City of Portland, Maine - Building or Use Permit Application

Job No: 2012-10-5193-CH-OF-USE <i>USE 2012-49305</i>	Date Applied: 10/16/2012	CBL: 032- E-004-001	
Location of Construction: 49 EXCHANGE ST (64 Market St)	Owner Name: ALBERT PALACCI	Owner Address: 4761 BROADWAY NEW YORK, NY 10034	Phone: 207-772-8107
Business Name:	Contractor Name: Benjamin Downs	Contractor Address: 68 Fellows St., South Portland ME 04106	Phone: (207)749-8235
Lessee/Buyer's Name: Darren Thomas	Phone: 207-671-5524	Permit Type: BLDG - Building	Zone: B-3
Past Use: Storage	Proposed Use: Restaurant (more than 9 seats & book store - change of use - tenant fit up	Cost of Work: 5000.00	CEO District:
		Fire Dept: <i>2/28/13</i> <input checked="" type="checkbox"/> Approved <input type="checkbox"/> Denied <input type="checkbox"/> N/A Signature: <i>Bjornald</i> (58)	Inspection: Use Group: <i>M</i> Type: <i>3B</i> <i>MUSEC '09</i> Signature: <i>JMB 1/29/13</i>
Proposed Project Description: Change of Use from Storage to Restuarant/Book Store		Pedestrian Activities District (P.A.D.)

Jeanie Bourke - Thomas Cafe 66 Market Street

A-1.1 FLOOR PLAN
THOMAS CAFE
DARREN THOMAS
66 MARKET ST. PORTLAND, ME 04101

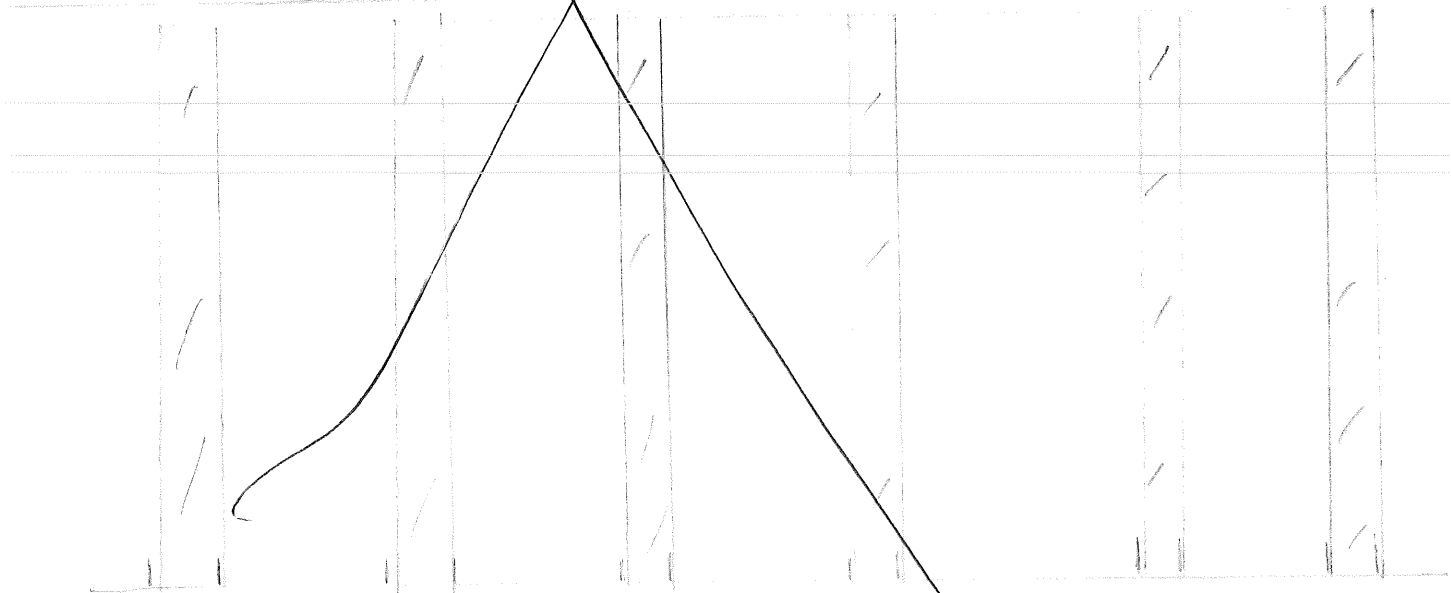
See Revisions
This highlights
The wrong space

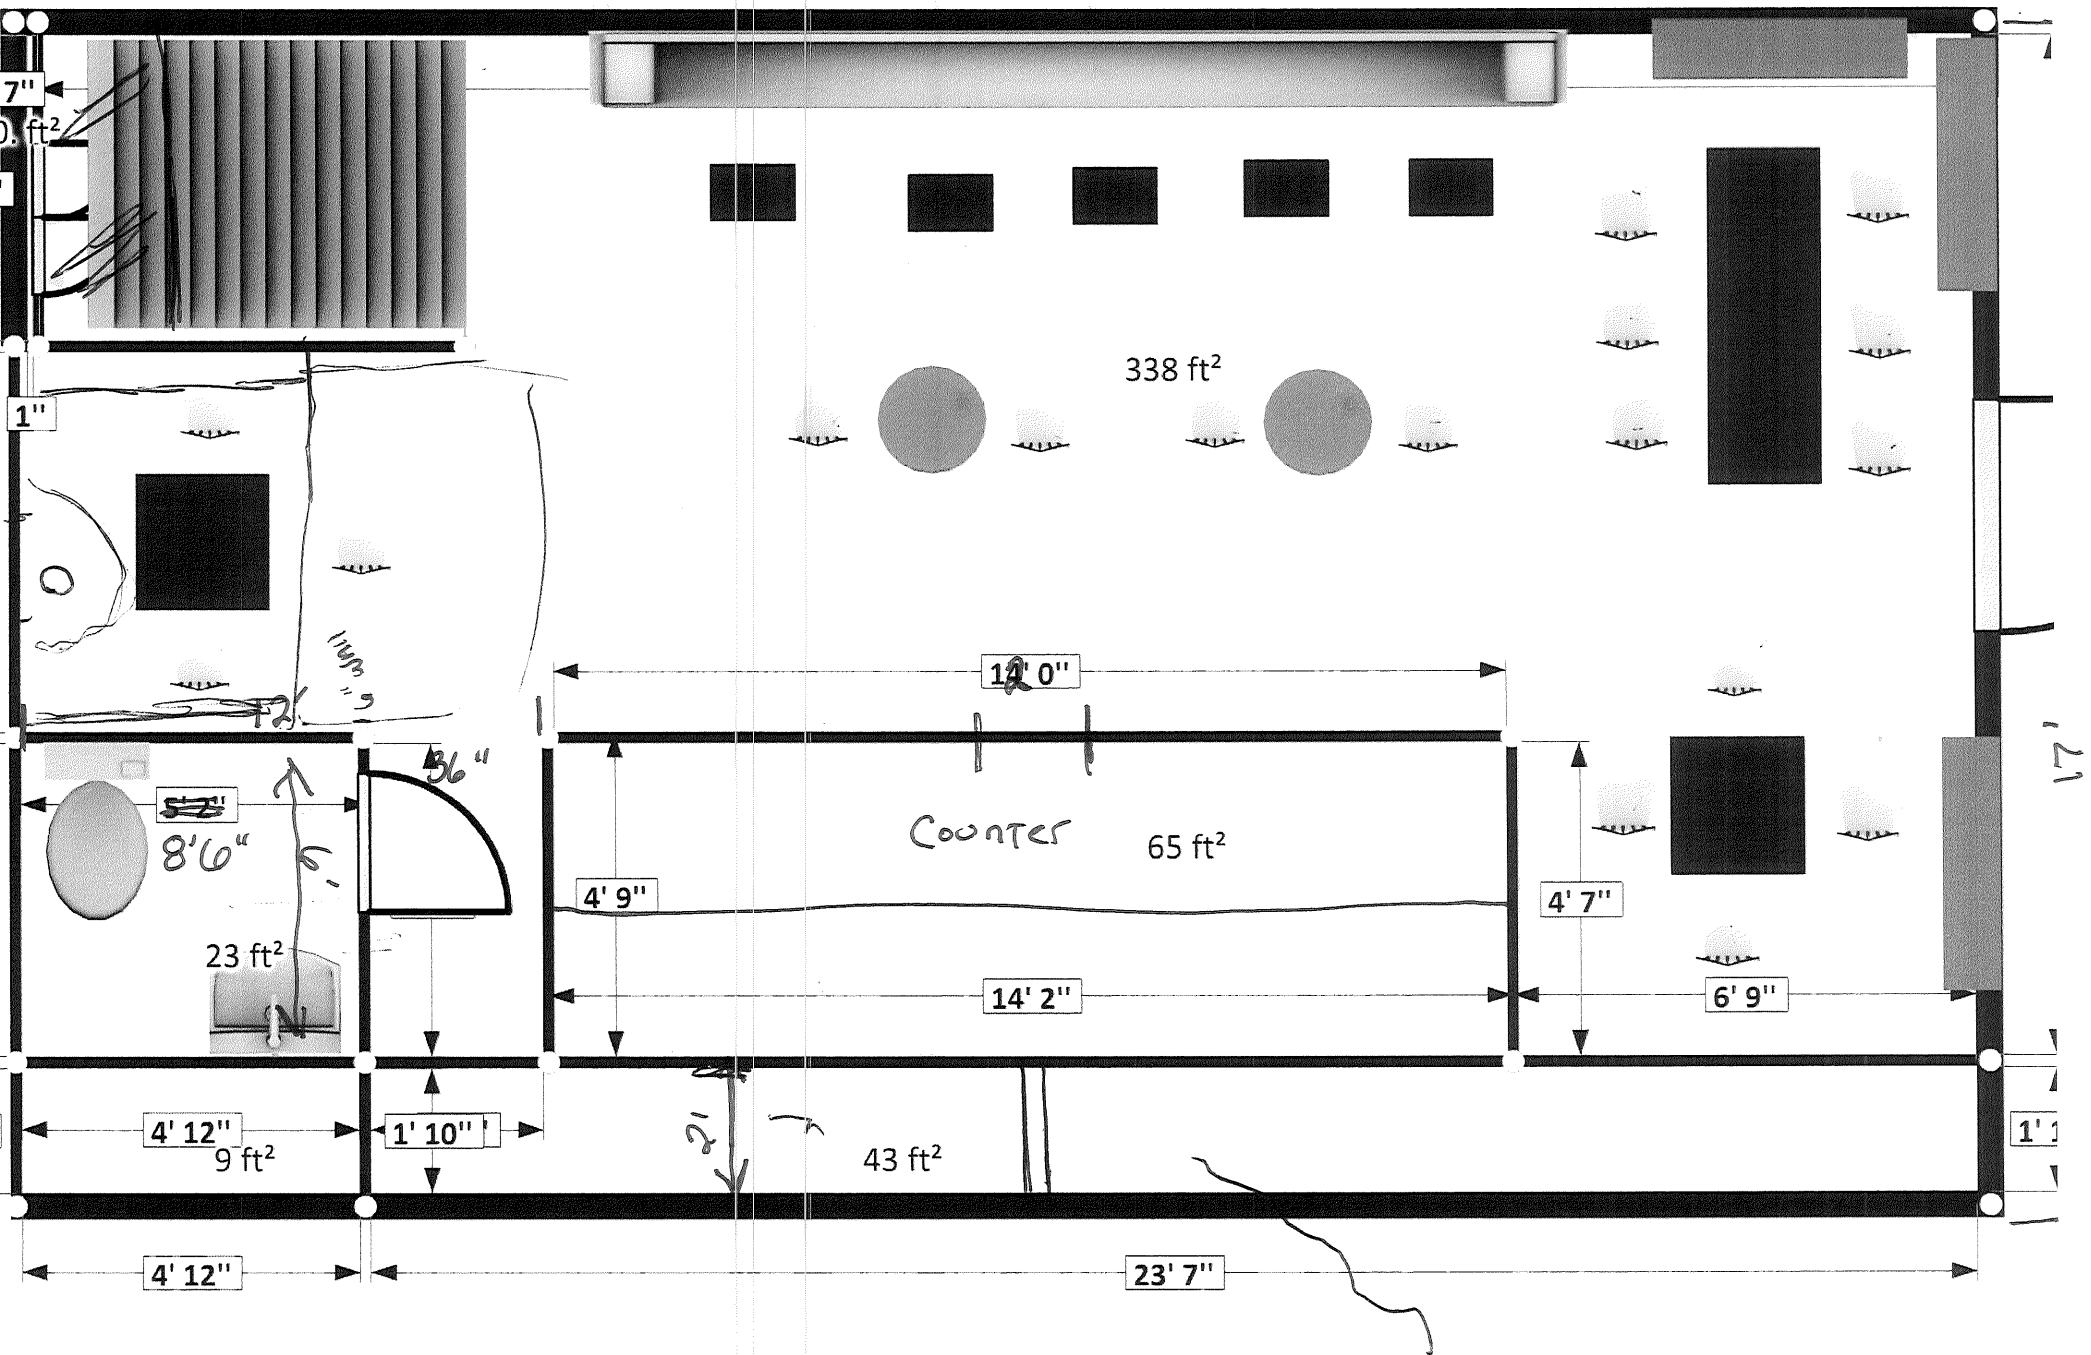
175 seats?

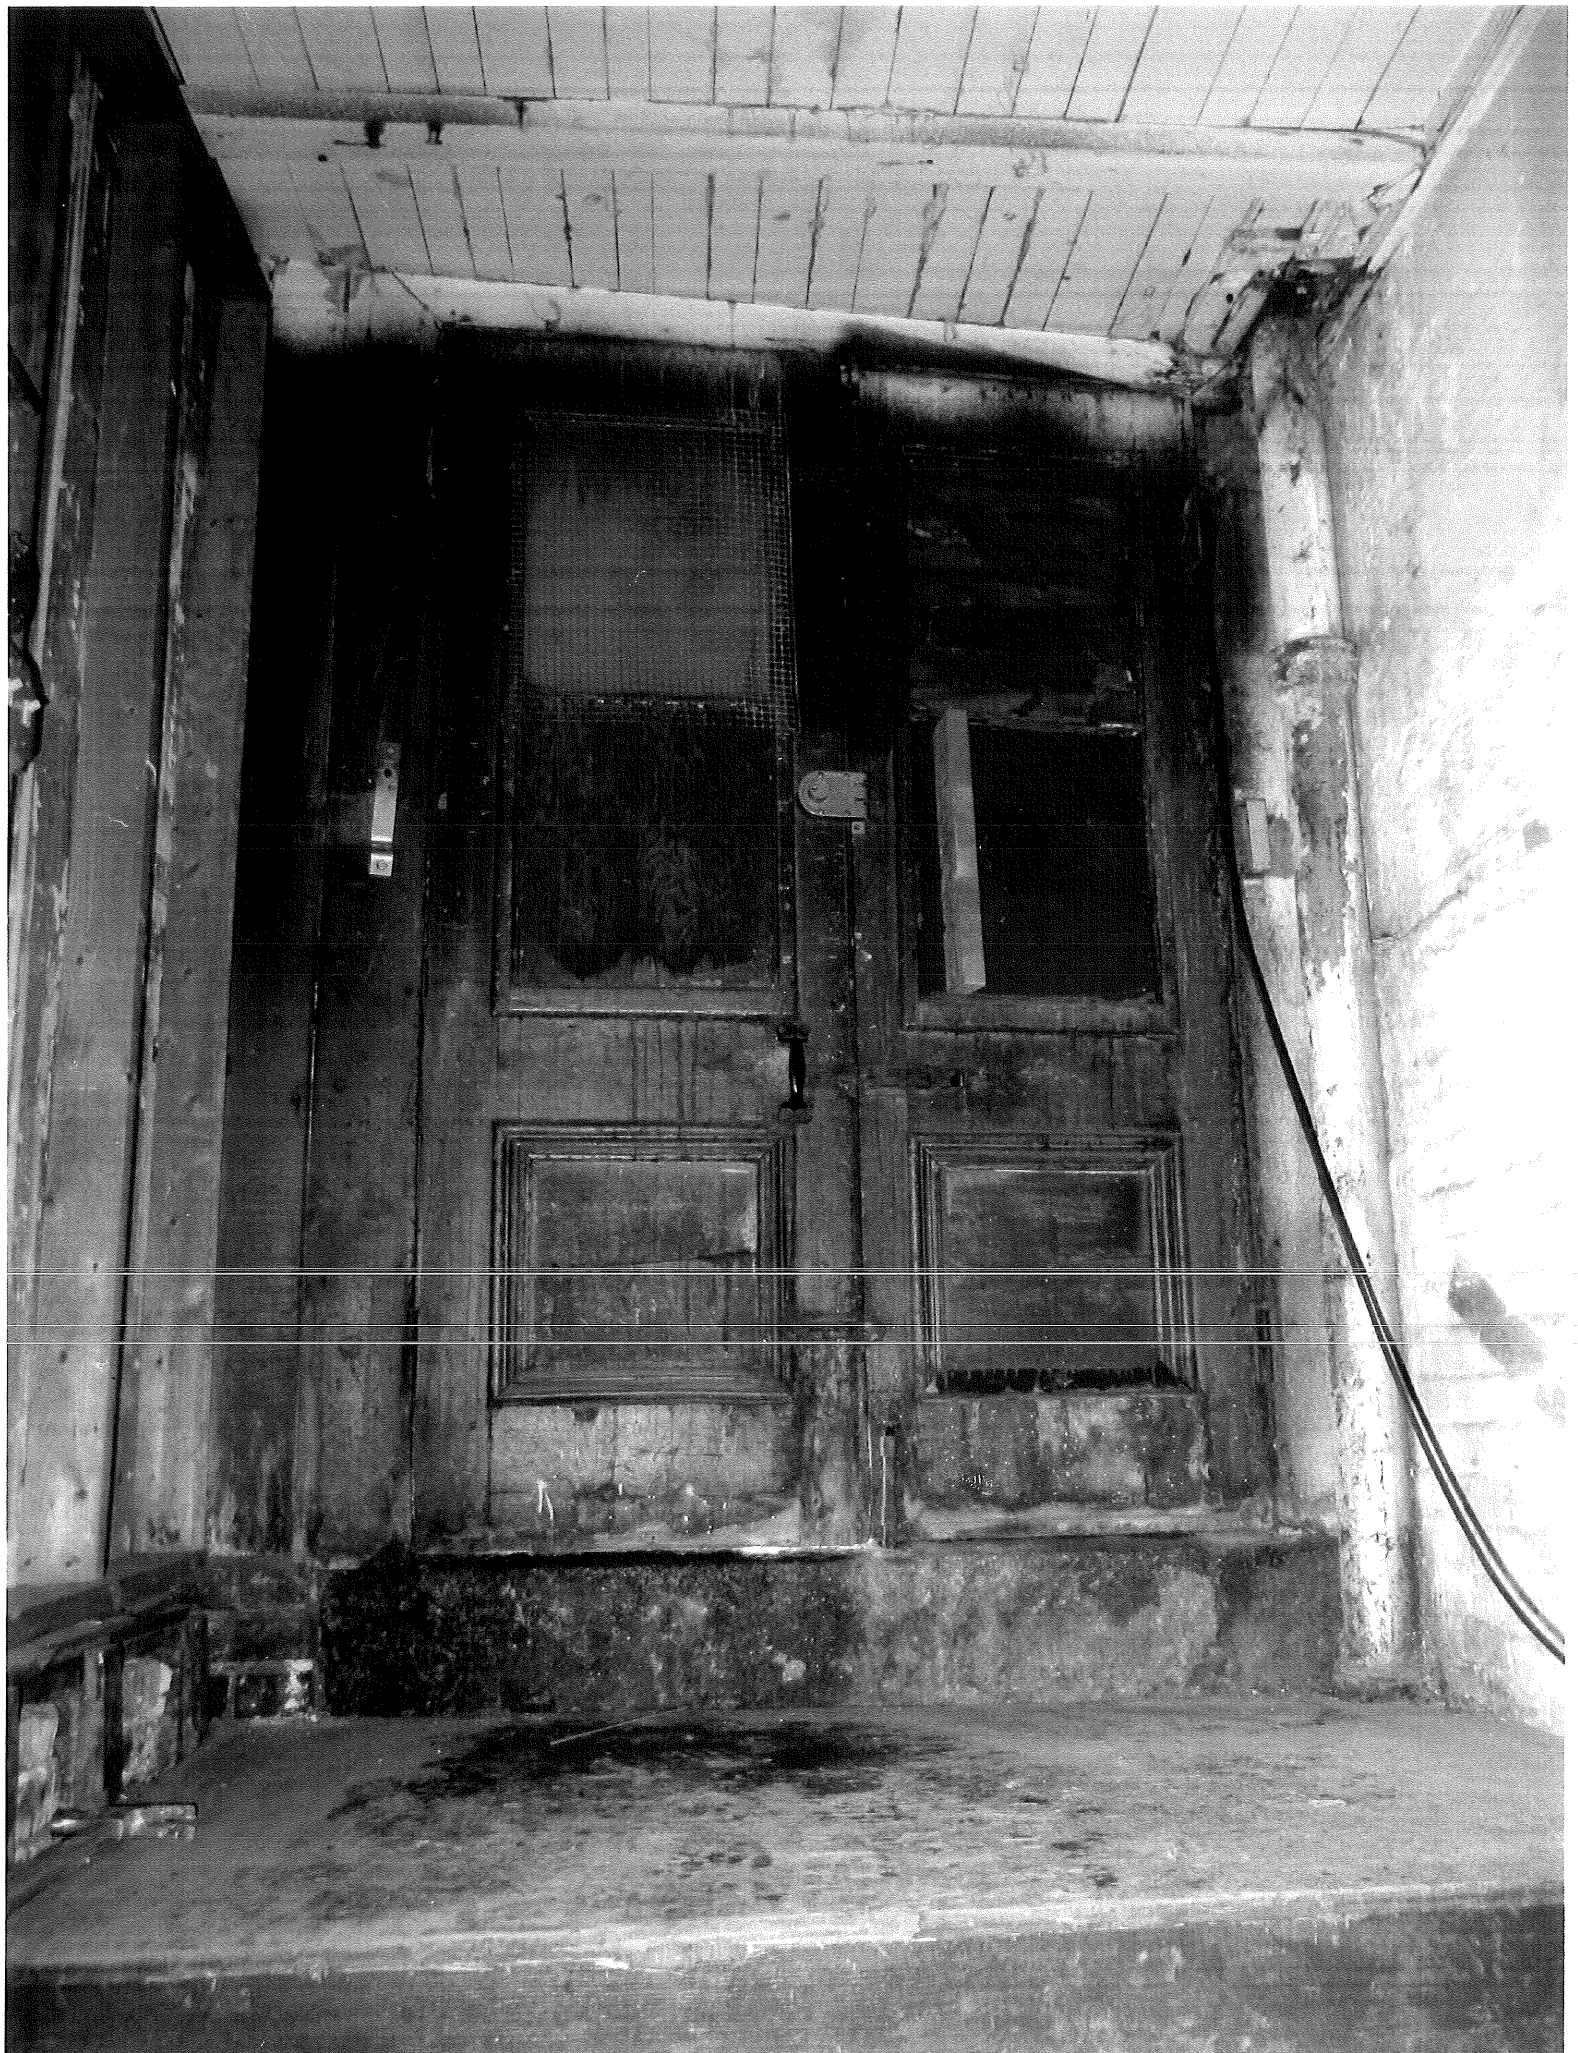
I know that there are still the code issues to work out, but as far as HP (historic Preservation) is concerned, we'll want some details on exactly how much the doors will be growing, how that will change the proportions, and how the kick plate will work to cover all the seams. For example, if the kick plate covers the full width that will hide the fact that the stiles (side pieces on the door, running vertically) don't run all the way to the bottom, as they will end and the addition to the rails (horizontal pieces) will go the full width, I imagine.

I think the work on the entrance is feasible - but we'll also want to see what the bottom will look like once the granite threshold is lowered. You and I talked a little about the treatment of the brickmold, and there might be a need to repair some brick work at the bottom. In addition to photos, I'm attaching the list of masons we have. There are others, I'm sure, but these are some we know who know how to work on old buildings.

The plan is to restore the doors to their original state. I've included some pictures of the inside of the doors so you can see the original design. Also in order to extend the old doors to accomodate the increased door height we would like to retro fit the doors with brass kick plate (bottom of doors). The idea is to reuse and refurbish the doors to original or better state.

A-1.1 FLOOR PLANS
THOMAS CAFE
 DARREN THOMAS
 66 MARKET ST, PORTLAND, ME 04101

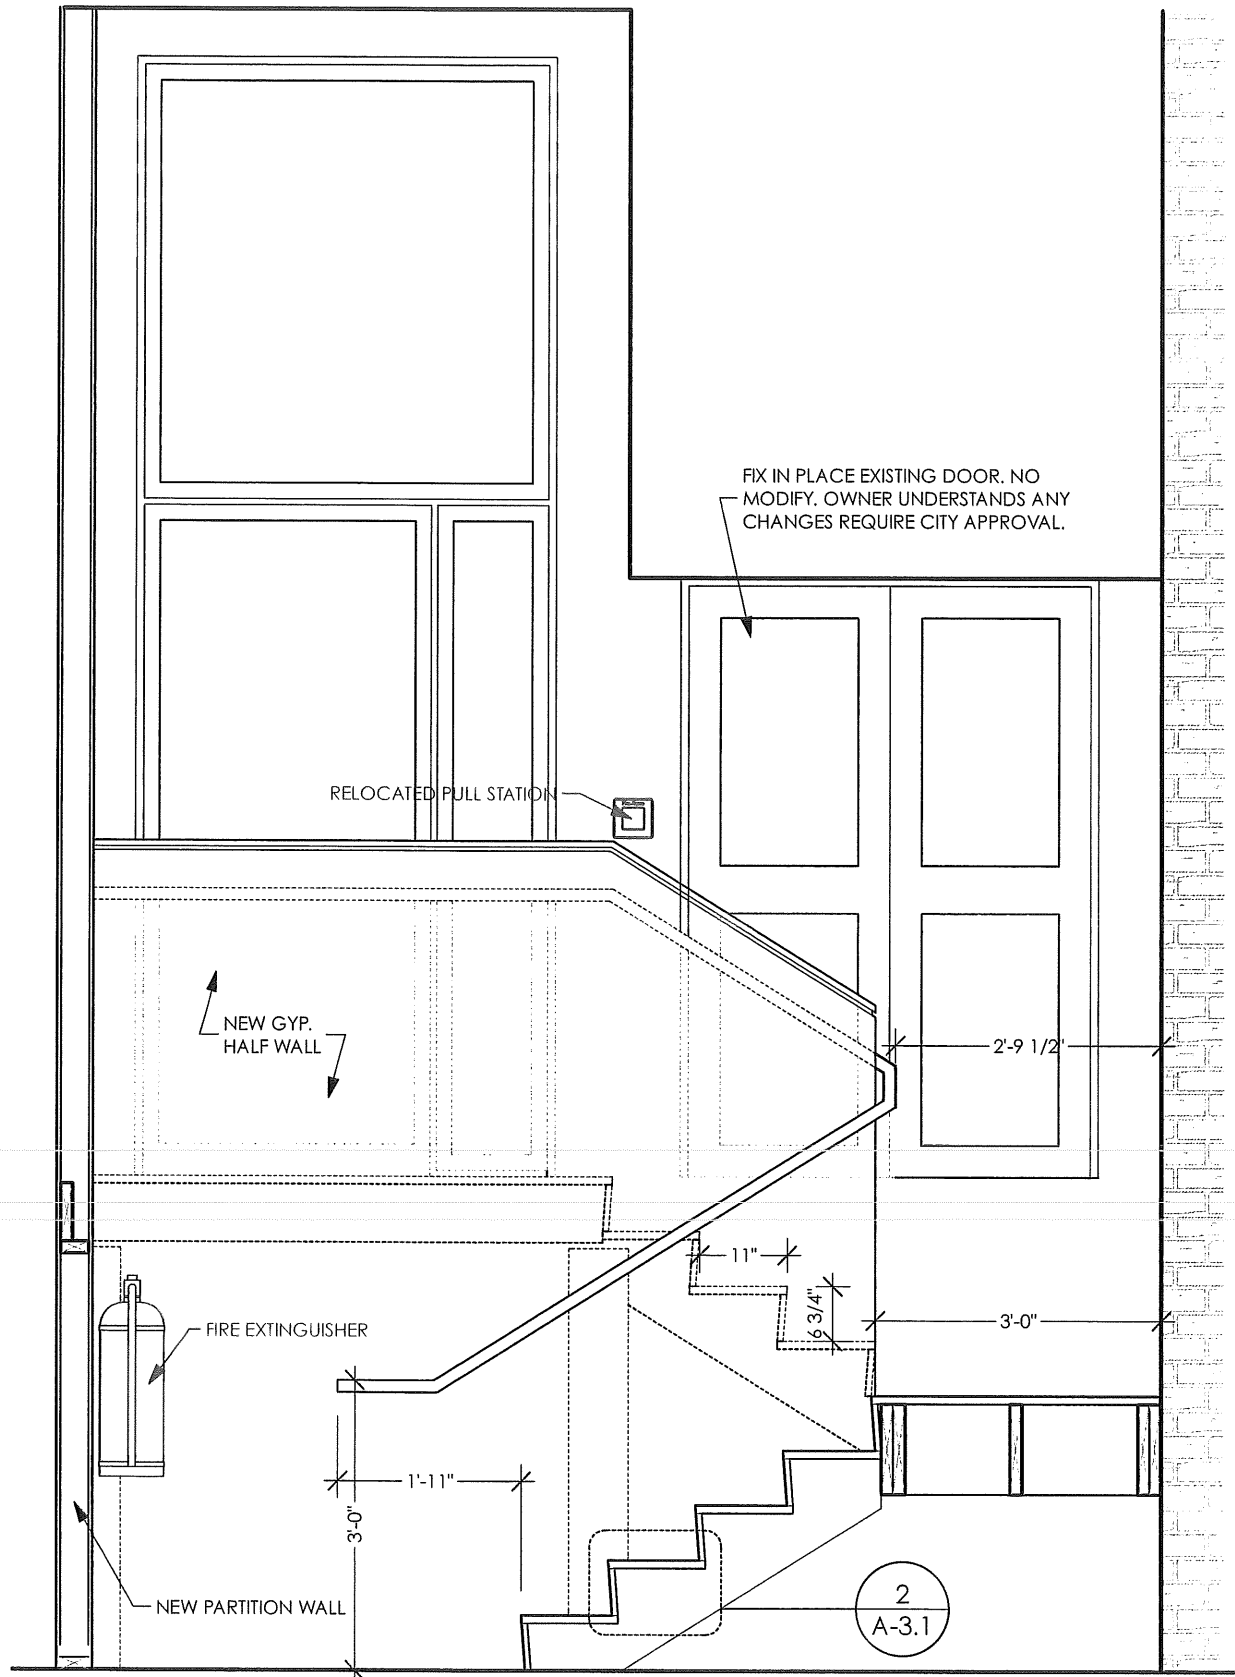
FIX IN PLACE EXISTING DOOR. NO MODIFY. OWNER UNDERSTANDS ANY CHANGES REQUIRE CITY APPROVAL.

See Revisions 1/9/13
